Appln No. 10/037,671

Reply to Office action of March 30, 2005

REMARKS/ARGUMENTS

FIG. 1

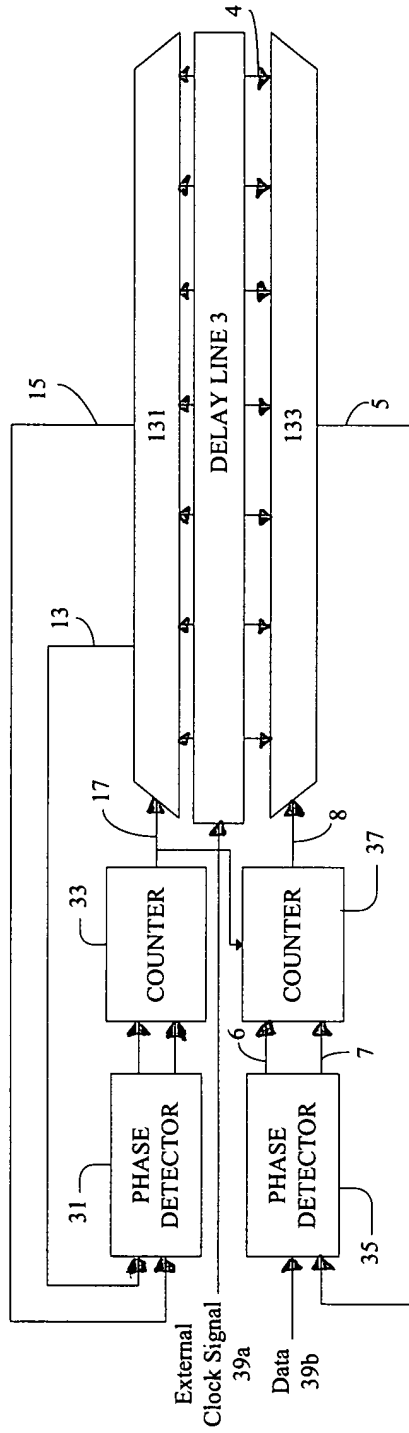
The drawings are objected to as FIGs. 1 and 3 were indicated as requiring arrows indicating the direction of the outputs and inputs to the components for better clarification. FIGs. 1 and 3 are now amended as indicated in the Office action.

The disclosure is also objected to as in FIG. 3, the labels 139a-d and D0+/- to D15+/- are not disclosed in the specification. The specification includes the drawings as filed, although the labels 139a-d and D0+/- to D15+/- are not mentioned in the text. The specification is now amended to indicate that the sampling signal 303 is provided as a clock input to clocked registers 139a-d, as can be seen in FIG. 3. The labels D0+/- to D15+/- are being canceled from FIG. 3.

The text discussing FIG. 3 indicates at one point that the delay line is item number 37. This has been corrected to indicate that the delay line in FIG. 3 is labeled as 137.

The attached sheet of drawings includes changes to FIGs. 1 and 3. The sheets, which includes Figs. 1 and 3, replaces the original sheets including Figs. 1 and 3.
